ROMERO
A-1 FIREWOOD

Drainage and
Grading Plan

C-1
SH. 1 OF 1

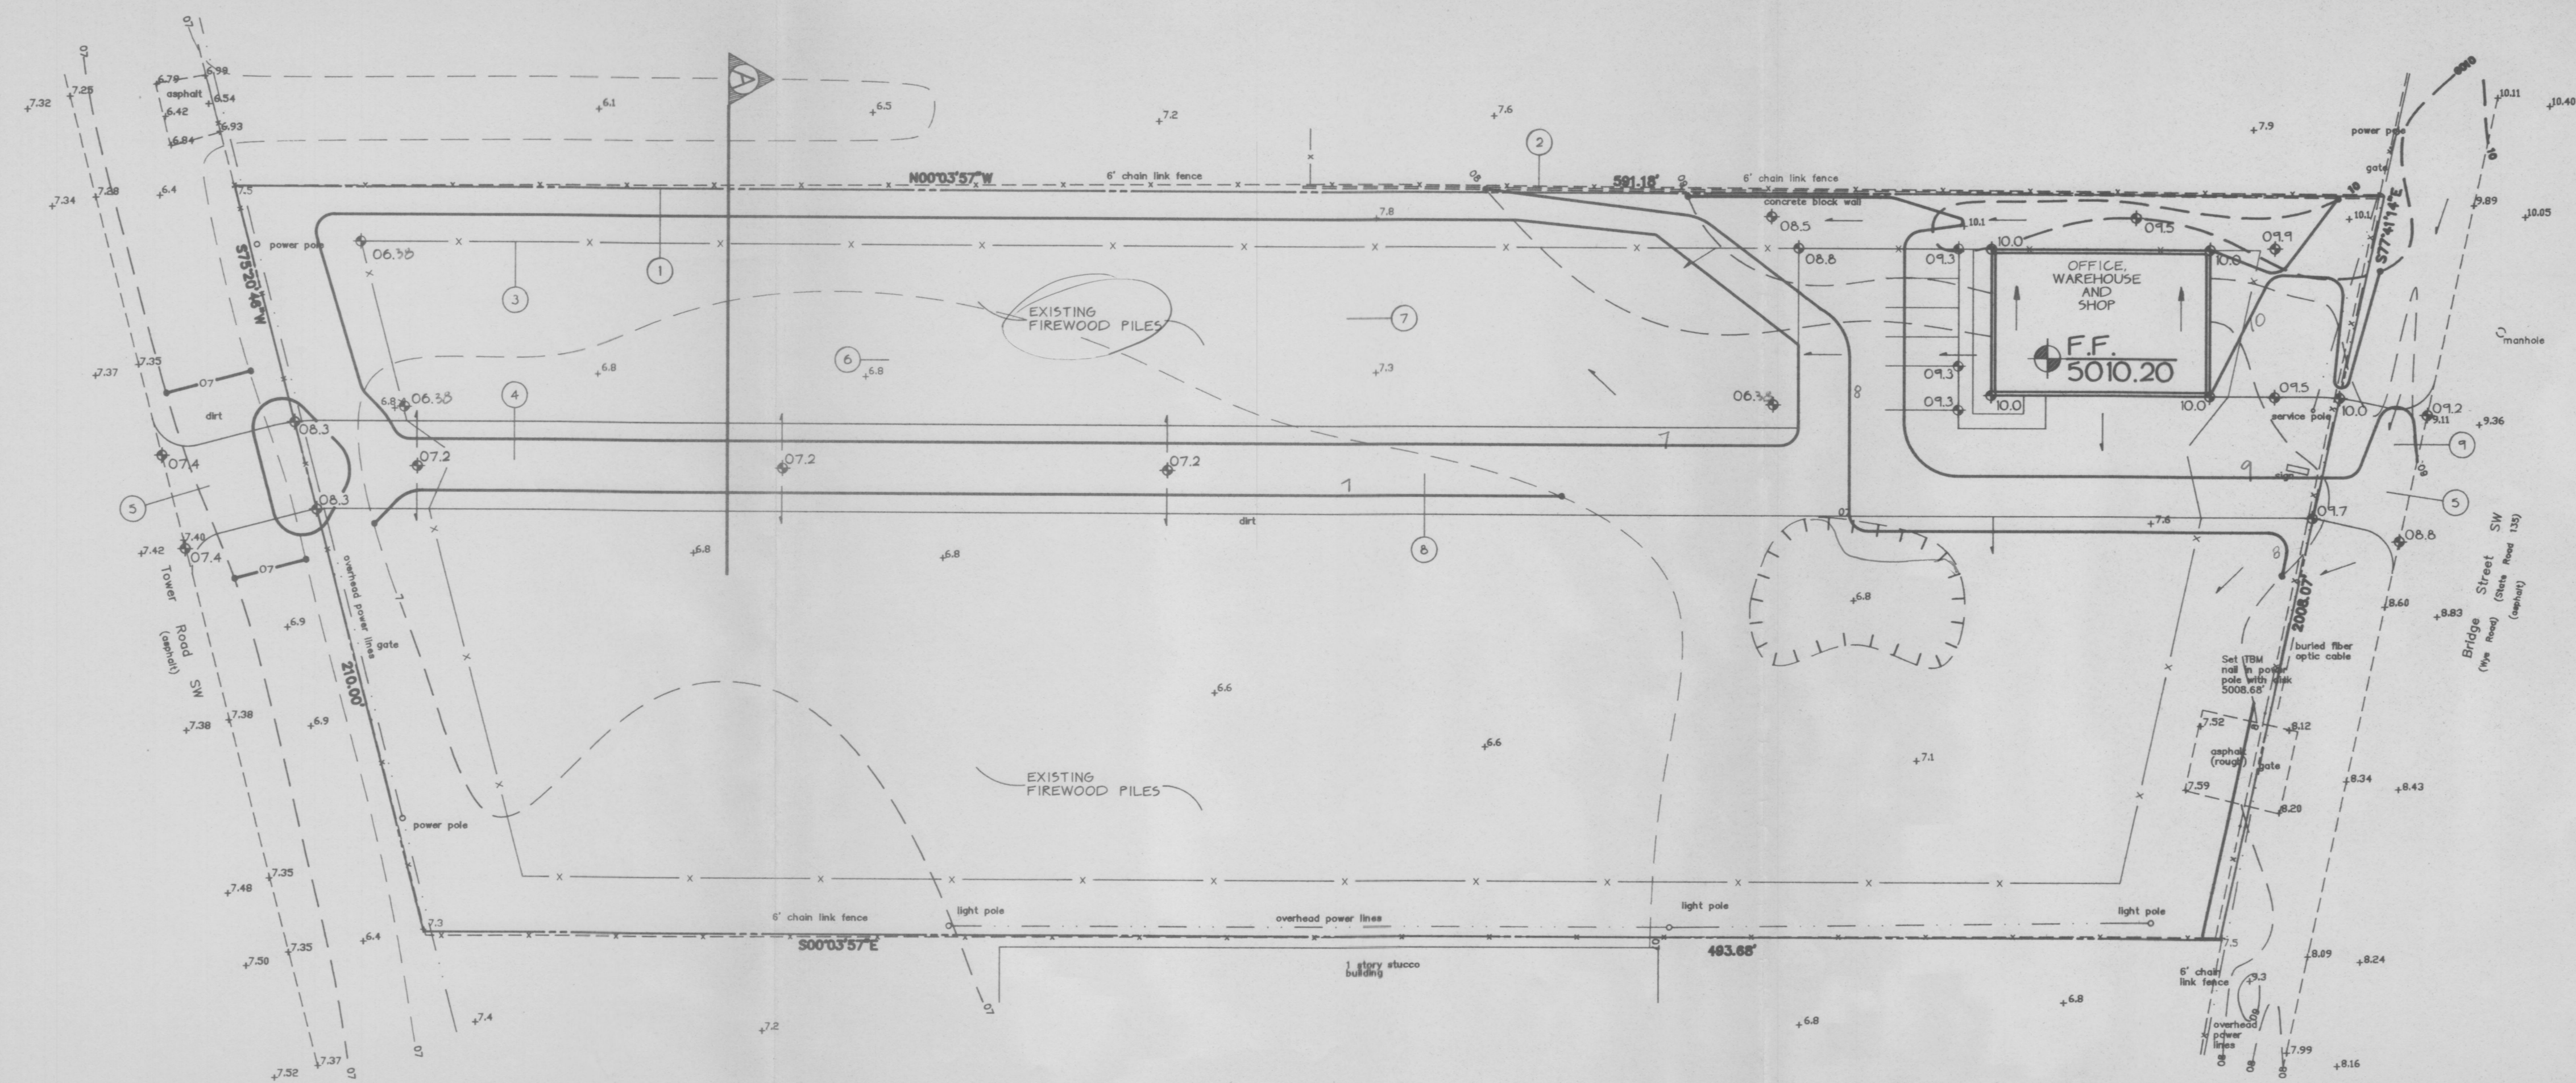
→ North?

on Prelim FEMA maps
this fp is gone
